SUBJECT: Savannah River Site's Responses to the Regulatory Comments on the 2022 K-Area Burning/Rubble Pit and Rubble Pile (131-K and 631-20G) (KBRP) and P-Area Burning/Rubble Pit (131-P) (PBRP) Operable Units Combined Groundwater Monitoring Report (Sampling Summary) SEMS Numbers: 40 and 59

SRS Responses to United States Environmental Protection Agency Comments on the 2022 K-Area Burning/Rubble Pit and Rubble Pile (131-K and 631-20G) (KBRP) and P-Area Burning/Rubble Pit (131-P) (PBRP) Operable Units Combined Groundwater Monitoring Report (Sampling Summary), SEMS Numbers: 40 and 59

SRS Responses to U.S. Environmental Protection Agency Comments on 2022 K-Area Burning/Rubble Pit and Rubble Pile (131-K And 631-20G) (KBRP) and P-Area Burning/Rubble Pit (131-P) (PBRP) Operable Units Combined Groundwater Monitoring Report (Sampling Summary), SEMS Numbers: 40 and 59, ARF-024225, Dated June 19, 2023

Figure 1. KBRP OU Monitoring Well Network, PCE and TCE Concentrations, and Water Elevation Measurements during 4Q22

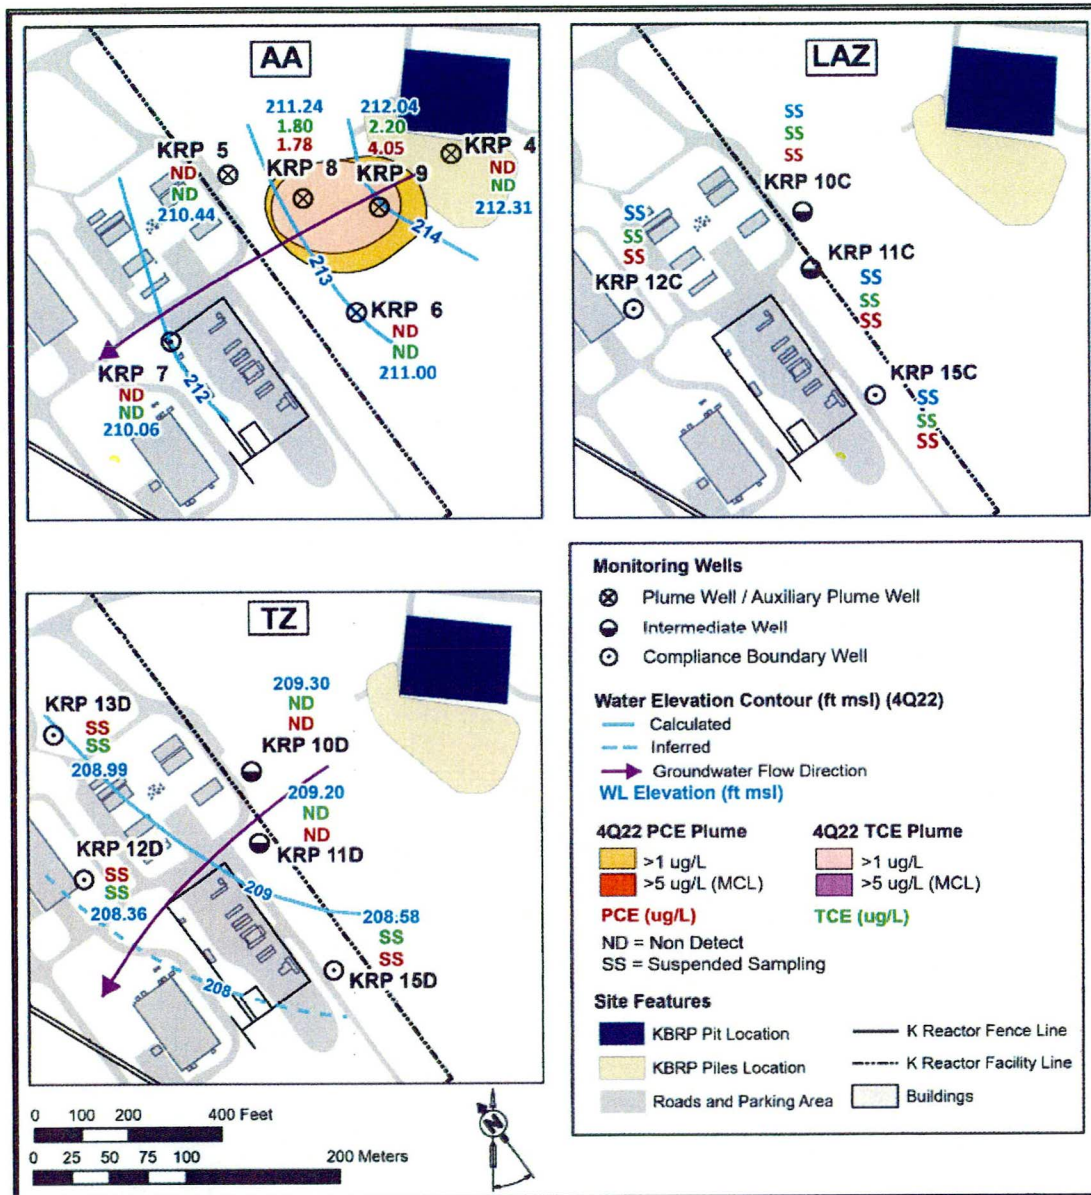
- 2. Figure 1, KBRP OU Monitoring Well Network, PCE and TCE Concentrations, and Water Elevation Measurements during 4Q22, Page 6:** The detection of trichloroethylene (TCE) at monitoring well KRP 9 is not shown on this figure to indicate a concentration greater than 1 microgram/liter (ug/L; i.e., light pink plume as noted in the legend). Table 2 (KBRP OU Monitoring Well Data) reports TCE detected at 2.2 ug/L at KRP 9 during the fourth quarter (October) of 2022. Therefore, the plume map for the AA aquifer should show the TCE at KRP 9. Please revise Figure 1 to include the detected TCE concentration at KRP 9.

The TCE plume in Figure 1 was inadvertently left out. The plume that was drawn was for PCE concentrations. The revised figure is shown at the end of these responses which includes the plume for TCE concentrations greater than 1 µg/L and less than the GWPS of 5 µg/L. No change to the current report is proposed.
